1.1. Old Business

Application to the HISTORIC DISTRICT COMMISSION, Nantucket, Massachusetts, for a

CERTIFICATE OF APPROPRIATENESS

2 East Elevation

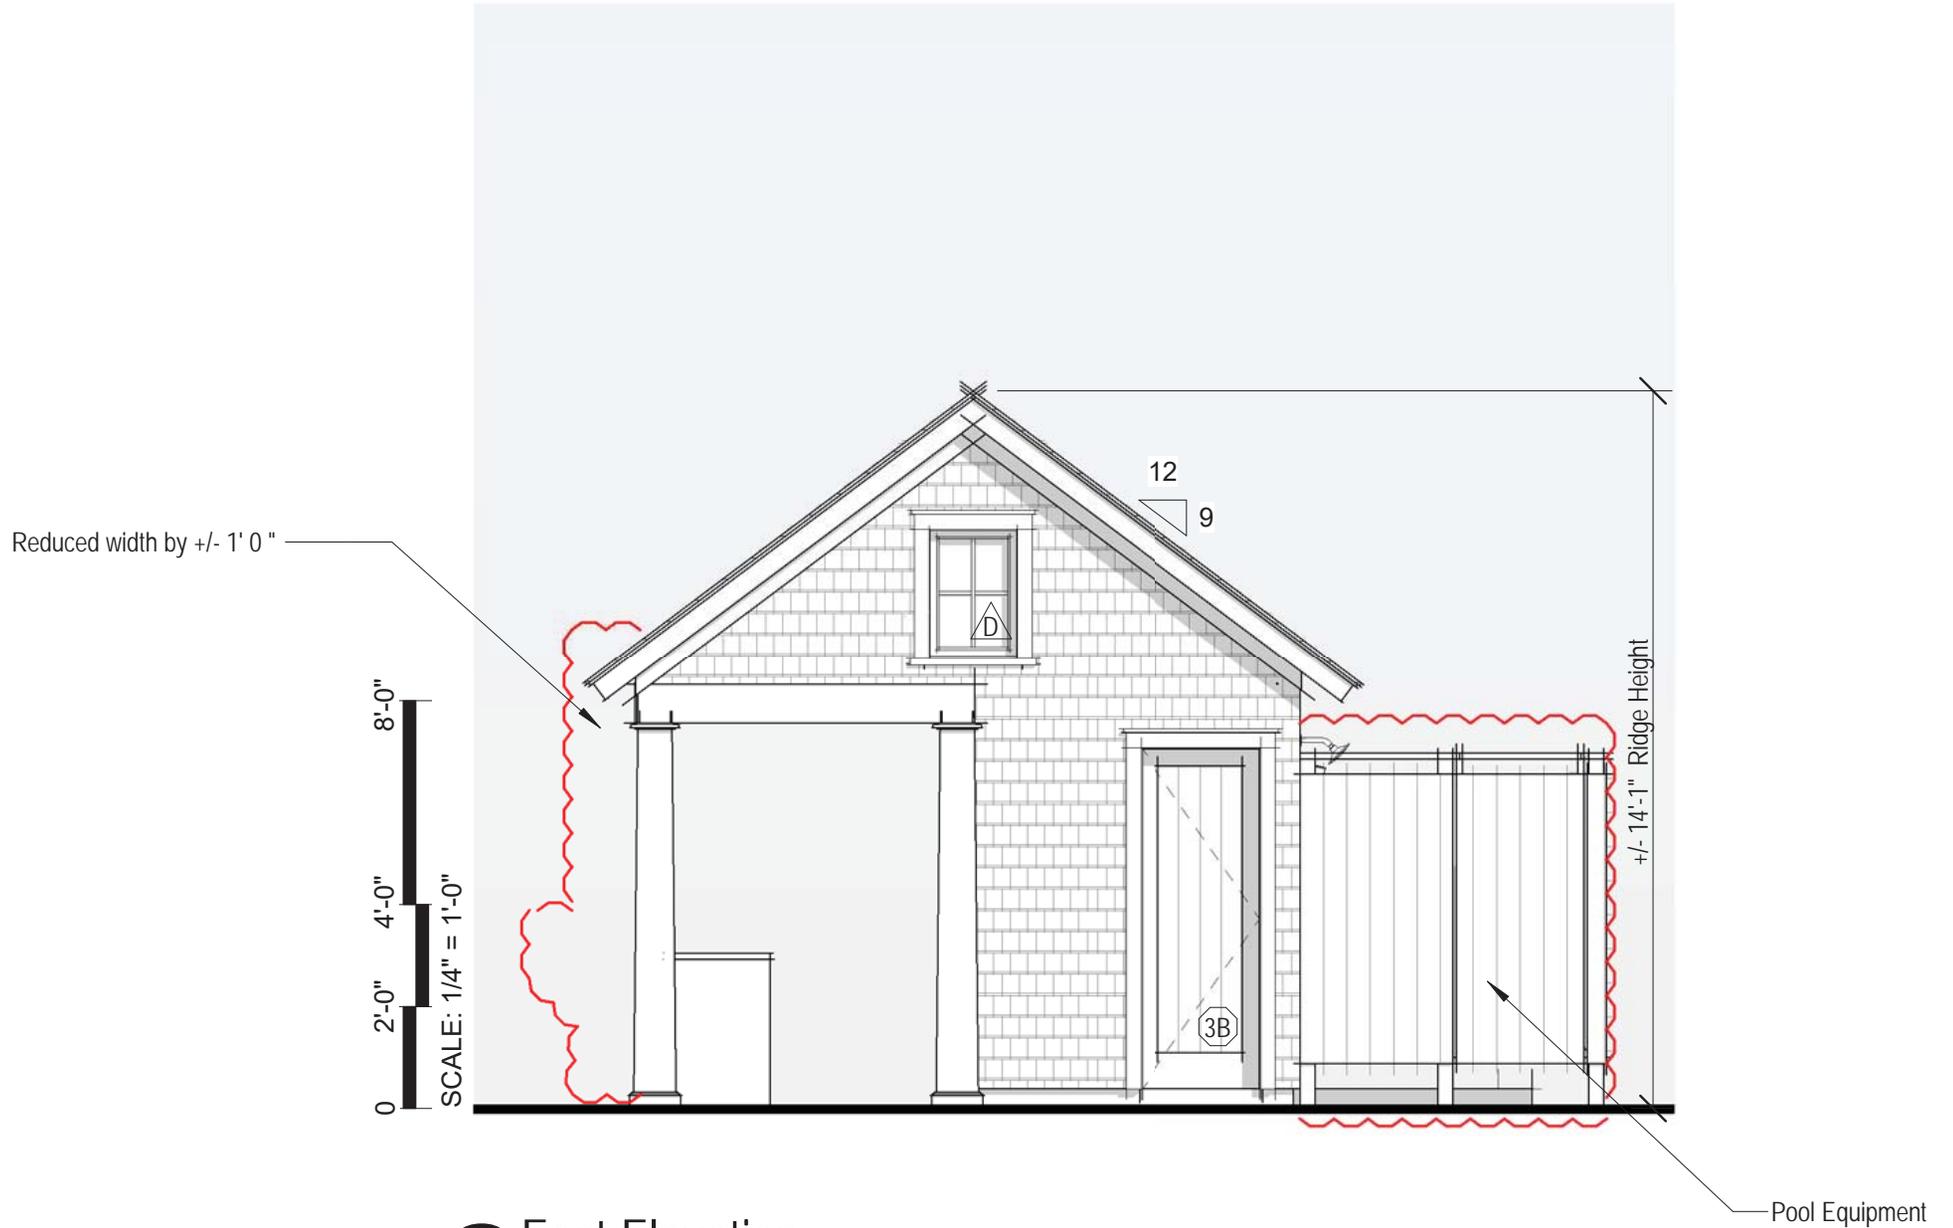
Fenestration changes
